## **Technical Service Information**

## **SATURN** MOVES FORWARD ALL GEAR SELECTIONS REVERSE AND/OR FORWARD WITH THE SELECTOR IN PARK OR NEUTRAL

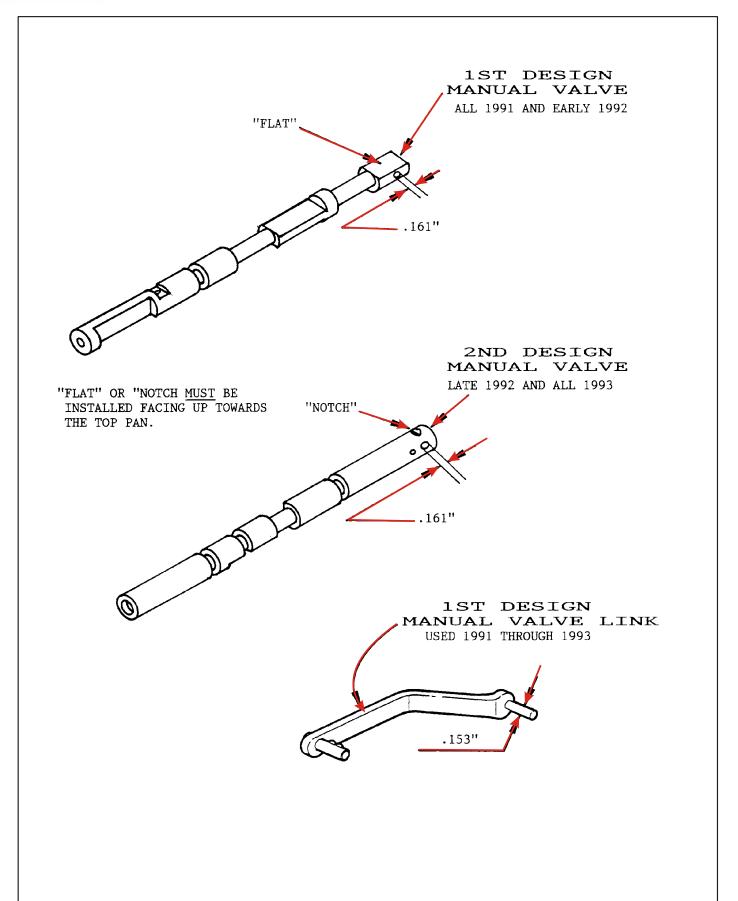
**COMPLAINT:** There are currently 3 different design levels of the Manual Valve, and 2 different design levels of the Manual Valve Link, that can create the complaints listed above if they are installed wrong, and/or parts mis-matched.

2nd design Manual Valve installed improperly with the "Notch" facing down towards the case. The "Notch" MUST face up towards the top pan (See Figure 1).

1994 (3rd Design) Manual Valve used with a 91-93 "Stamped Form" Manual Valve Link, that allows extra play in the shift linkage because of mis-matched parts. Refer to Figure 2 for dimension differences

**CORRECTION:** On ALL 1991 to 1993 models, remove the valve body and orient the Manual Valve with the "Flat" (1st Design) or "Notch" (2nd Design) on the Manual Valve facing <u>UP TOWARDS</u> THE TOP PAN, as shown in Figure 1. Reinstall the valve body and torque to proper specifications.

> Install the proper design level Manual Valve Link with the matching Manual Valve. Functionally, the 1994 (3rd Design) Manual Valve is the same as the late 1992 and 1993 (2nd Design) Manual Valve. There are two different stem diameters on the Manual Valve Links, where it goes into the manual valve.

1st design "Stamped Form" Manual Valve Link is used on all 91-93 models, and the stem diameter is .153" (See Figure 1).

2nd design "One Piece Wire" Manual Valve Link is used on all 1994 models, and the stem diameter is .194" (See Figure 2).

As a result of the change to the Manual Link, the hole in the Manual Valve also had to increase in diameter from .161" to .202", to accommodate the 2nd design manual link (See Figure 2). There was also a plastic cap added to the 1994 (3rd Design) Manual Valve as an assembly aid to prevent the manual valve from being installed to the manual link backwards (See Figure 2).
